C S Stokes and Associates Limited

16th December 2015

Subject: HIU's within the hallways of some Grenfell Tower flats which are located on the existing electrical supply/distribution board cupboard.

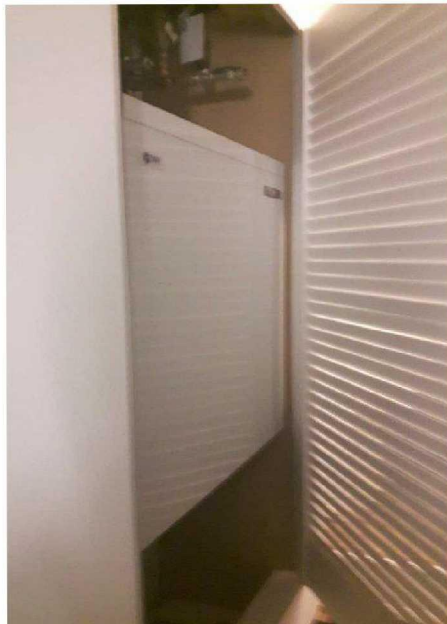
Please see a photograph on the left below, (A) this was taken on Tuesday the 15th December 2015 within one of the flats where the HIU is positioned on the wall just inside of the flat entrance door on top of the electrical cupboard. The local Authority Building Control Officer has agreed the location of this unit in the hallway of the flats concerned and this location complies with the requirements of the Building Regulations. This includes the Fire Safety aspects of the Regulations, so by complying with the requirements of the Fire Safety, Approved Document B of the Building Regulations the positioning also will comply with the requirements of the Regulatory Reform (Fire Safety) Order 2005.

The photograph on the right (B) below shows the overhang of the timber constructed cupboard with a louvered door containing the HIU in comparison to the existing electrical supply/distribution board cupboard. The width of the hallway is 1170mm, the existing electrical supply/distribution board cupboard comes out from the wall 180mm and the HIU cupboard comes out from the wall 330mm. There is a 150mm overhang by the HIU cupboard into the hallway more than the electrical cupboard.

This leaves a clear width/gap of 840mm from the front face of the HIU cupboard to the other wall of the hallway. All of the above measurements were taken from one flat but the width of the hallways is the same within each dwelling and from what I have been told the HIUs have been positioned in similar locations. Photograph C below shows the HIU within the timber constructed cupboard with a louvered door open.

In Approved Document M (ADM) of the Building Regulations, "Access and use of Buildings", which includes disabled access arrangements it states in item 6.23 that the requirements of Part M will be satisfied if an external door providing access for a disabled person, to a dwelling, has a minimum clear opening width of 775mm. The clear width of the hallway within the flat I looked at had a clear width of 840mm, this is greater than the minimum width required by ADM for the entrance door. Again if the requirements of ADM are complied with then the requirements of the Regulatory Reform (Fire Safety) Order 2005 and also The Disability Discrimination Act 2005 (DDA) and the Equality Act 2010.
